Subject: Draft Corrective Measures Proposal, EMD Chemicals Inc. Cincinnati Facility,
Revision 2

Draft Response to USEPA Comments on EMD Chemicals Inc Draft Corrective Measures Proposal

Response to U.S.EPA Comments on EMD Chemicals Inc. Draft Correct Measures Proposal

Figure 3
Facility Map
EMD Chemicals Inc.
Corrective Measures Proposal
Figure Prepared by The Payne Firm, Inc.

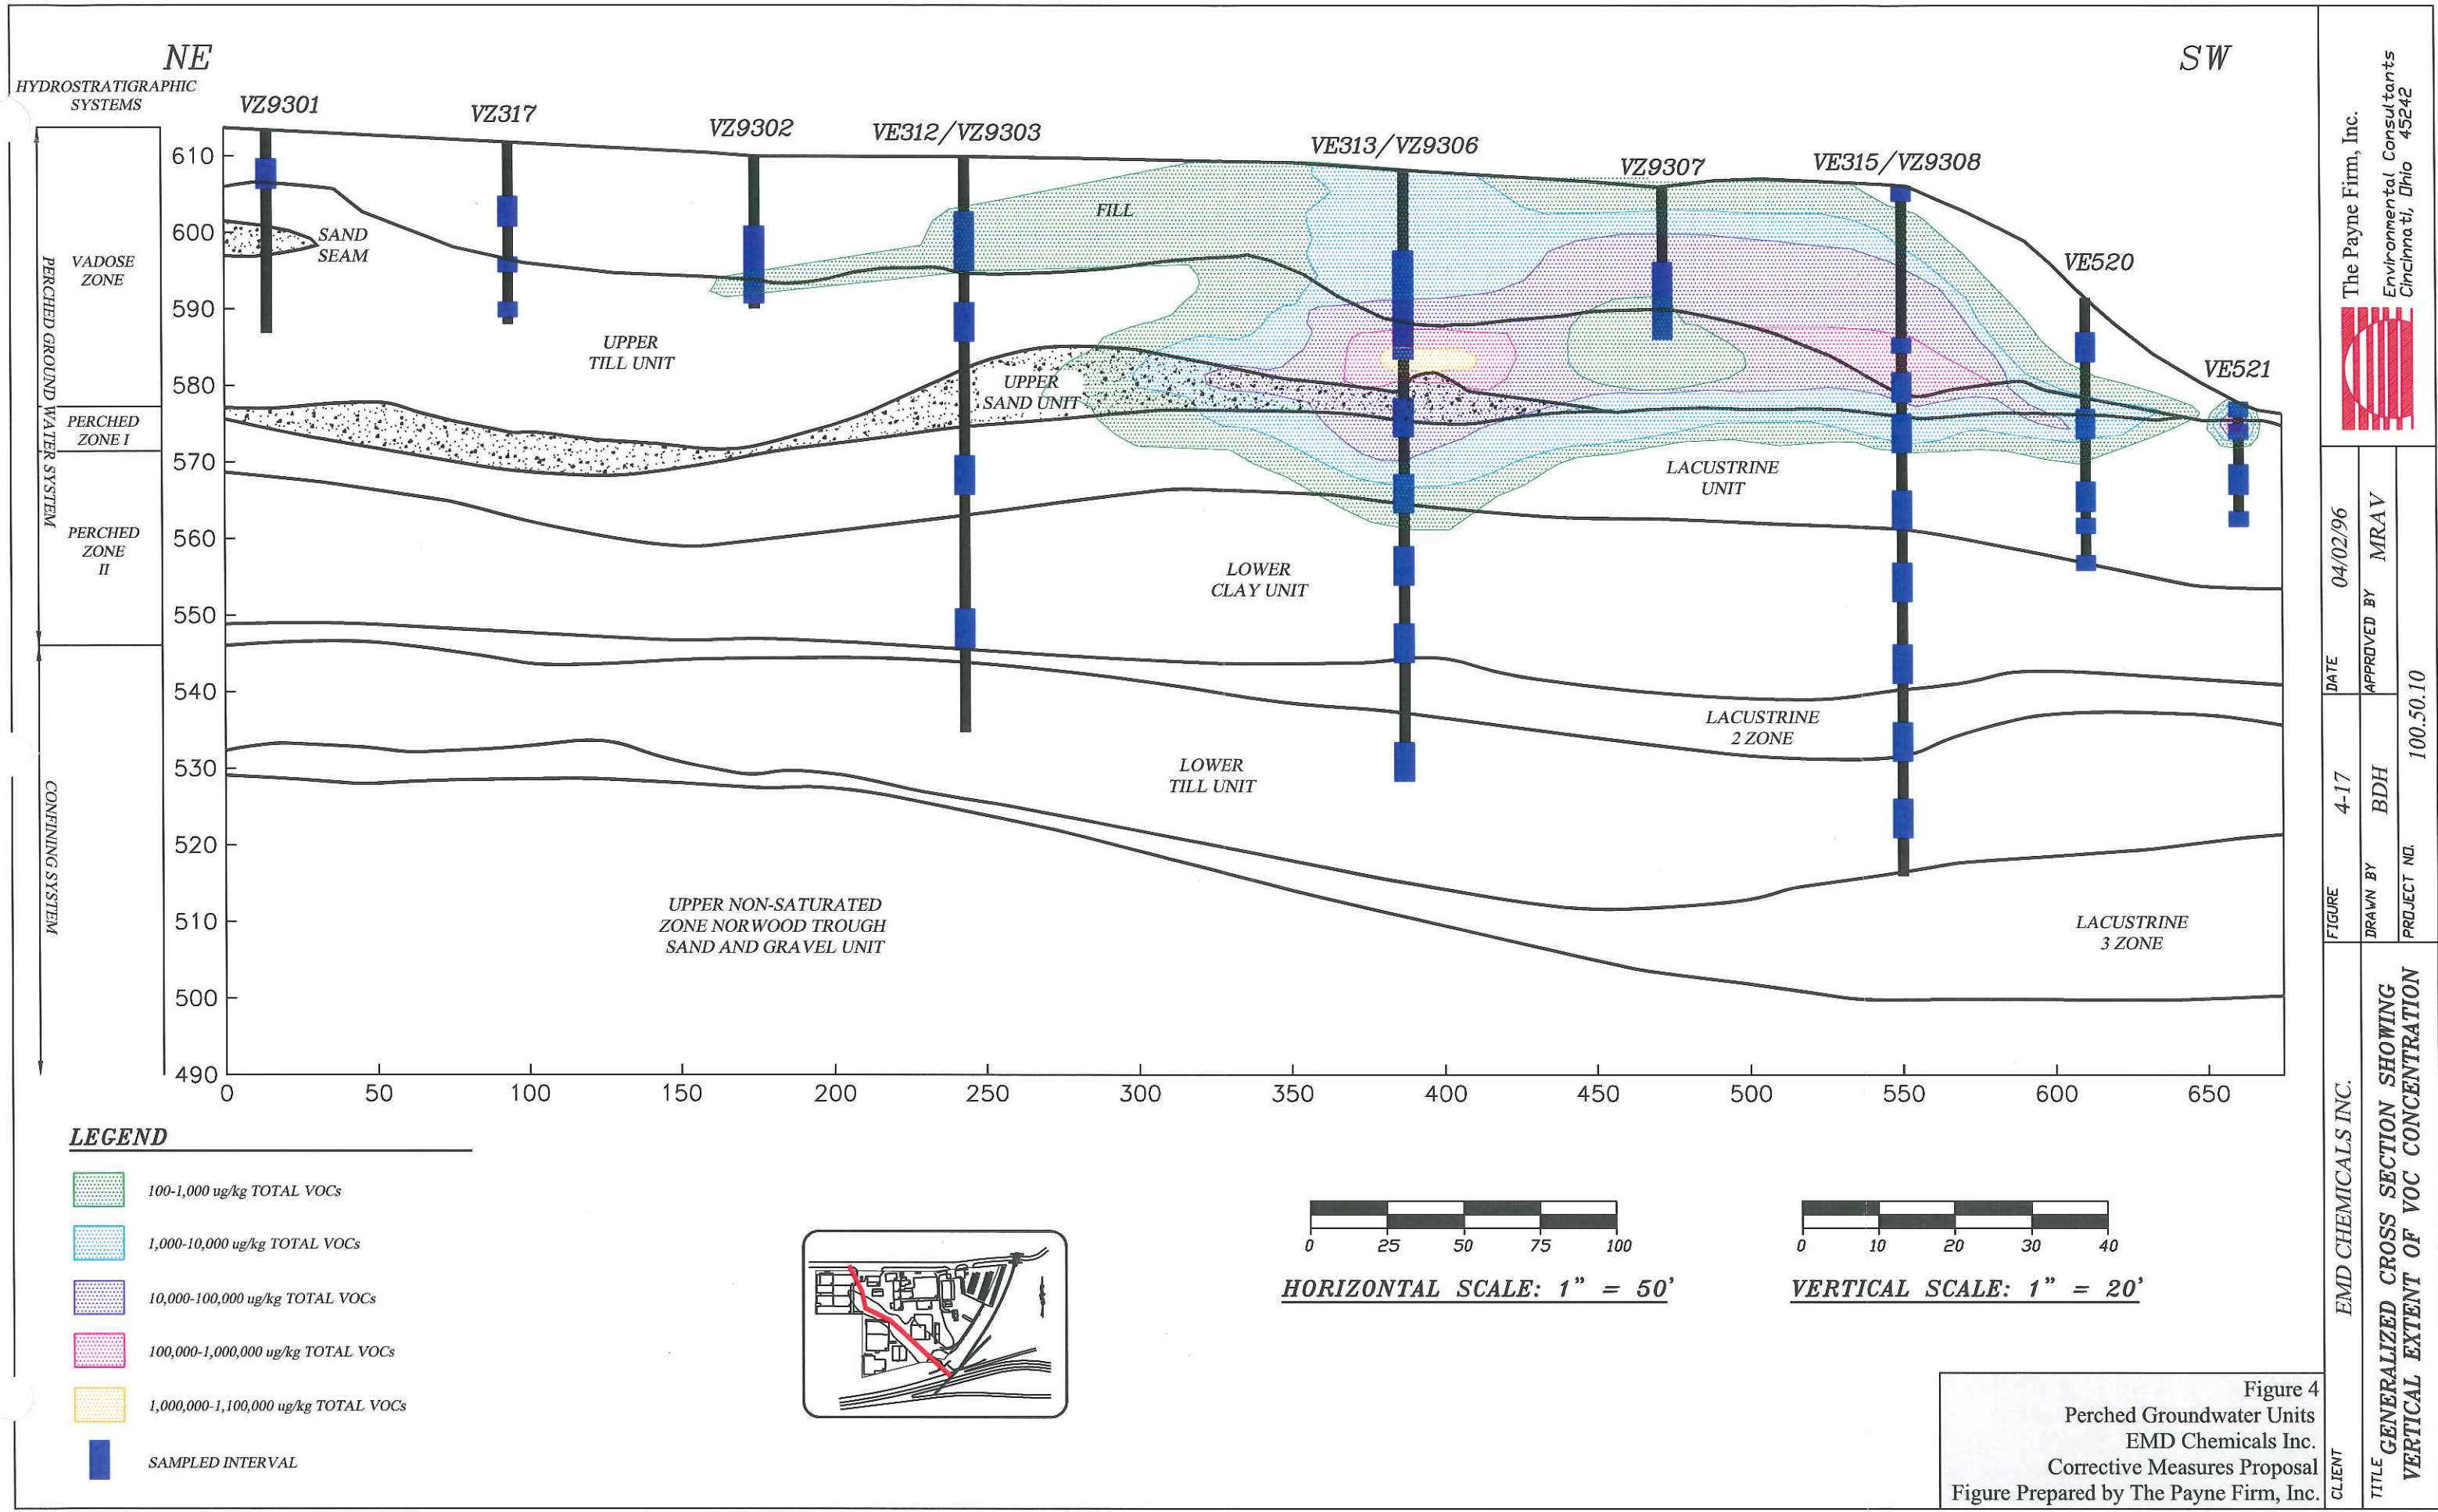
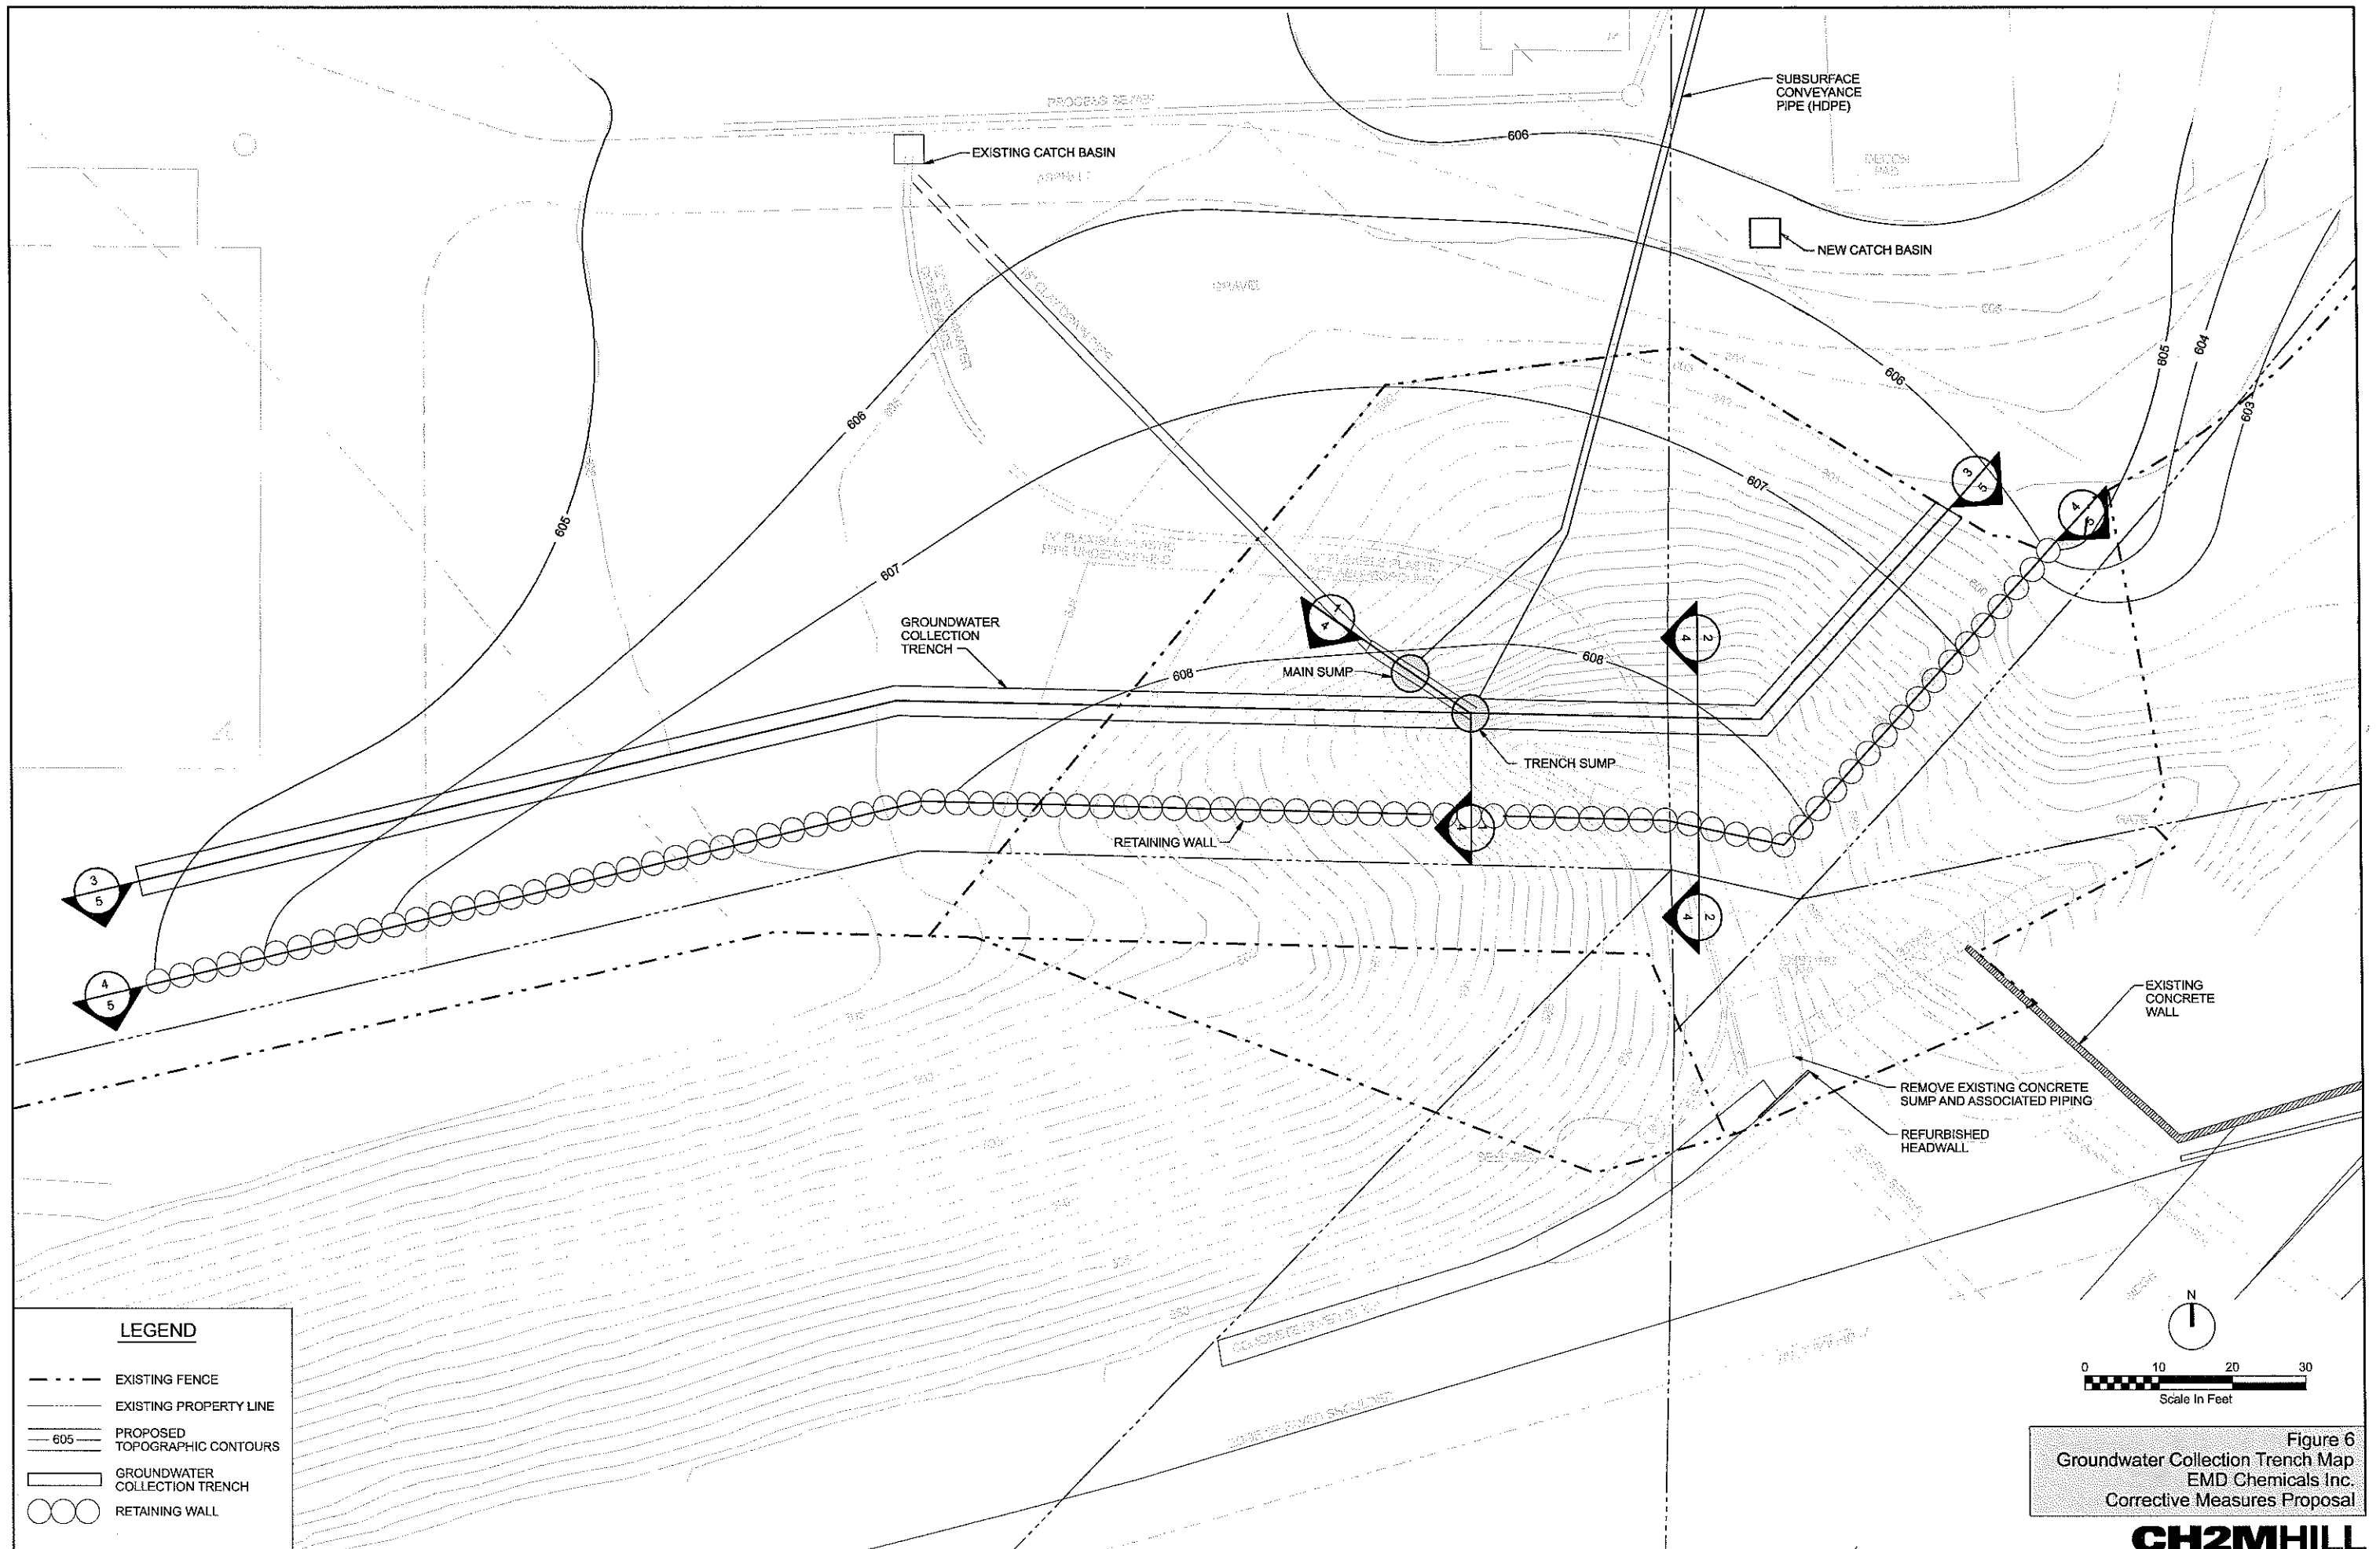
Comment 1: Revise Figure 3 to show the location of the former tank farm area. Emphasize in text that most of it lies over the West Ravine.

Comment 1: *Revise Figure 3 to show the location of the former tank farm area. Emphasize in text that most of it lies over the West Ravine.*

Response – The figure will be revised to show the location of the former tank farm area and a discussion added to the text. However, the majority of the former tank farm does not lie over the West Ravine, it is to the west. The proposed location of the trench is designed to capture downgradient migration from the former tank farm location.

Response – The figure will be revised to show the location of the former tank farm area and a discussion added to the text. However, the majority of the former tank farm does not lie over the West Ravine, it is to the west. The proposed location of the trench is designed to capture downgradient migration from the former tank farm location.
